**CONWAY**  
HISTORIC DISTRICT COMMISSION  
STAFF REPORT

**5:30pm • May 29, 2018 • City Hall**

**ROBINSON HISTORIC DISTRICT  
CERTIFICATE OF APPROPRIATENESS REVIEW  
CLARK NEW PARKING LOT  
1517 CALDWELL STREET**

**OLD CONWAY DESIGN OVERLAY DISTRICT  
CERTIFICATE OF APPROPRIATENESS REVIEW  
MCKINNEY REMODEL AND ADDITION  
923 PARKWAY STREET**

Site plan with Staff comments

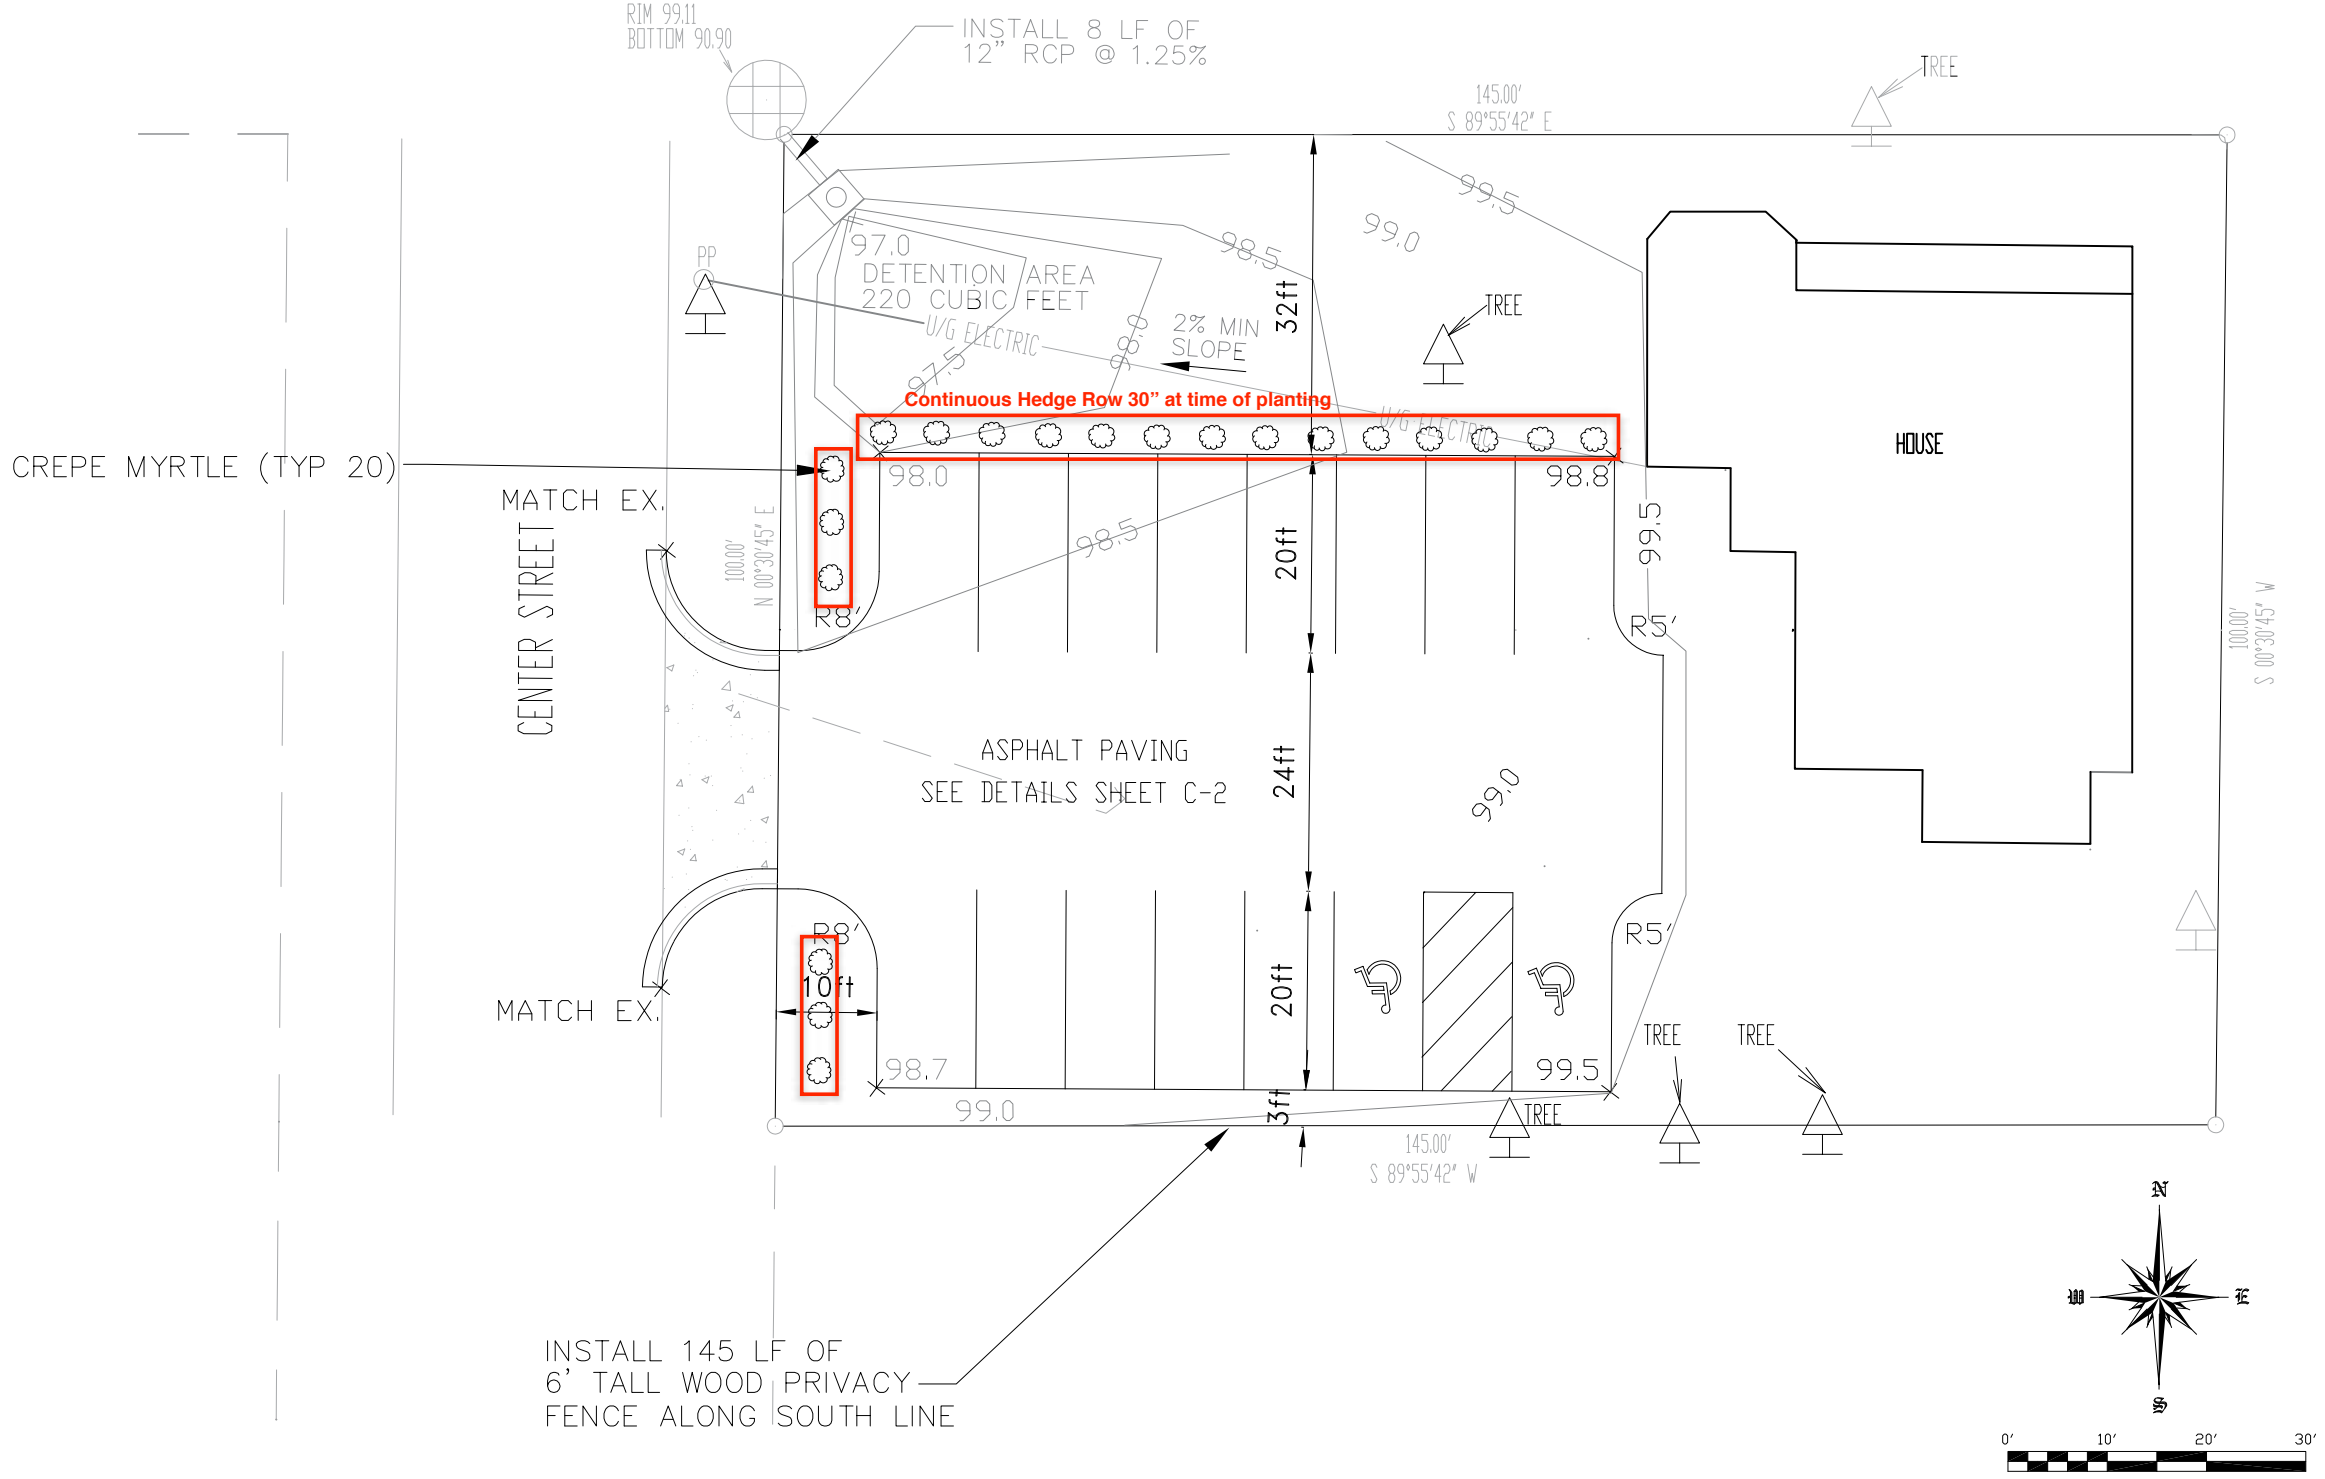
The proposed site plan shows crepe myrtles surrounding the parking area. Crepes can be used but would be in addition to the required screening hedge.

Robinson District Guidelines state that new parking should be as unobtrusive as possible and must be screened from street view by a substantial planting strip or a combination of plantings and fencing. Residential parking may be gravel or concrete. Commercial parking may be concrete, asphalt, or pavers. The front of the parking lot should not extend past the fronts of adjacent structures. A corner parking lot should be screened from both streets.

The proposed parking lot is for a repurposed residential structure now used as a realty office. Although the parking lot will serve a commercial purpose, it should be constructed to blend with abutting residential uses. As a commercial parking lot, asphalt can be seen as appropriate. The submitted plan shows a landscape drainage detention area with a concrete detention structure in the northwest corner of the property. It is likely, that this drainage detention area and structure will not be necessary. The plan also shows cape myrtles as a screening measure. Planning Department development review regulations don't allow crepe myrtles as trees, however, they could serve as a partial screening measure. Development review regulations require a parking lot to be screened with a continuous hedge row that is 30 inches high at the time of planting. A vertical element such as crepes would add to the required hedge row screening.

A typical 6 foot tall privacy fence is also planned along the south property line. There are several similar abutting privacy fences. Robinson District Guidelines call for the top 2 feet of a 6 foot privacy fence to be 50% opaque through the use of wooden lattice. The proposed privacy fence will be viewable from Caldwell and Ash Street.

With appropriate landscaping screening measures, staff recommends approval of the new parking lot with the following conditions:

1. The parking lot asphalt area shall be constructed as shown in submitted plans.
2. A continuous hedge row screening the parking area shall be required as shown on Staff sketch.
3. Vertical "accent" plantings shall be required as per Staff sketch.
4. Tree and shrub species shall be determined as part of Planning Staff development review.
5. Lighting shall be determined as part of Planning Staff development review.
6. A 6 foot tall wooden privacy fence shall be allowed along the south property line. The upper 2 feet 50% opaque through the use of wooden lattice?

Staff created concept photo

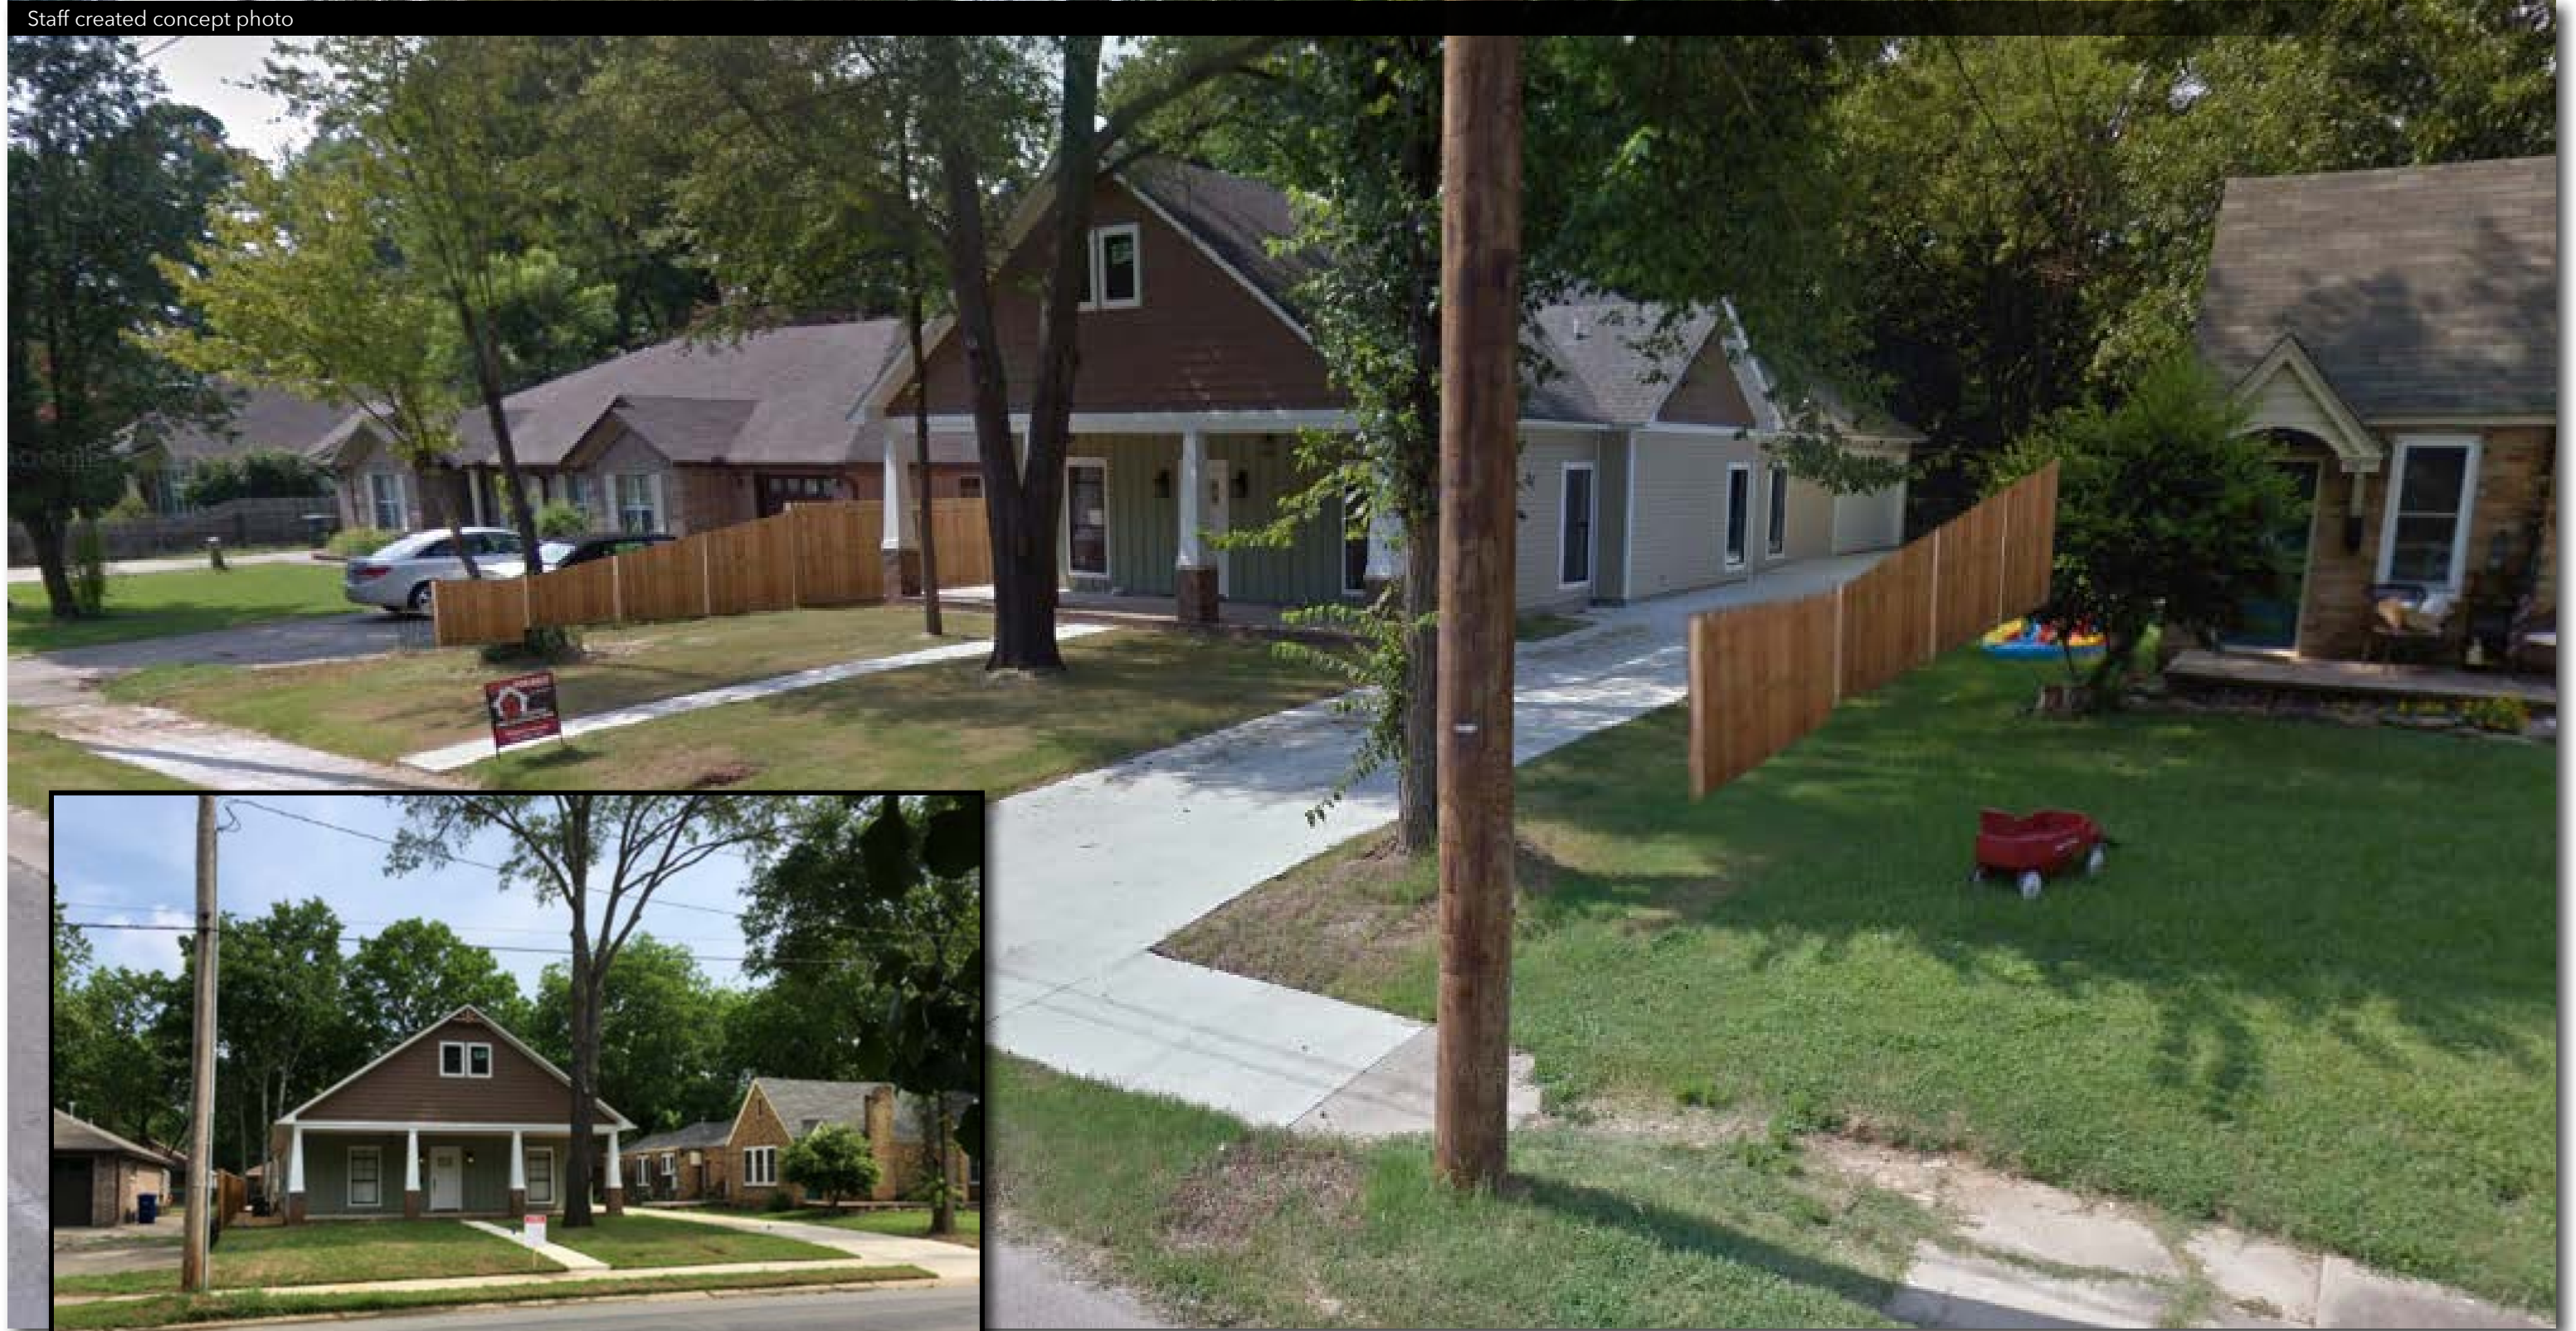
The proposed fence design is a typical 6 foot wooden privacy fence. The applicant would like to enclose the rear yard with this type of fence. In addition, the fence would be extended 18 feet beyond the house on the east and west sides tapering from 6 feet high to 4 feet high. There is an existing section of privacy fencing on the west extending to the front of the porch. There is also a small decorative metal fence extending beyond this section of privacy fence. The end of the metal fence is roughly 18 feet beyond the residence.

The majority of the privacy fence will be unseen at the rear of the yard. The most visible part will be a small 6 foot wide enclosing section on the west and the tapering sections along the east and west property lines. There is a similar older fence tapering from 6 feet to 4 feet two houses to the west.

Guidelines call for the upper 2 feet of 6 foot tall privacy fences to have a lattice pattern. The existing fence does not have this feature. The rear portions of the fence would not be seen.

Staff recommends approval of the fencing and driveway concrete expansion with the following conditions:

1. A 6 foot tall wooden privacy fence shall be allowed around the rear of the property as shown on submitted site plan.
2. The wooden privacy fence shall be allowed to extend 18 feet beyond the residence as planned. This section of fence shall taper from 6 feet to 4 feet across the 18 foot distance?
3. New sections of 6 foot privacy fence along the east property line and enclosing section on the west shall have the upper 2 feet 50% opaque through the use of wooden lattice?
4. A new section of driveway concrete shall be allowed as shown on submitted plan.
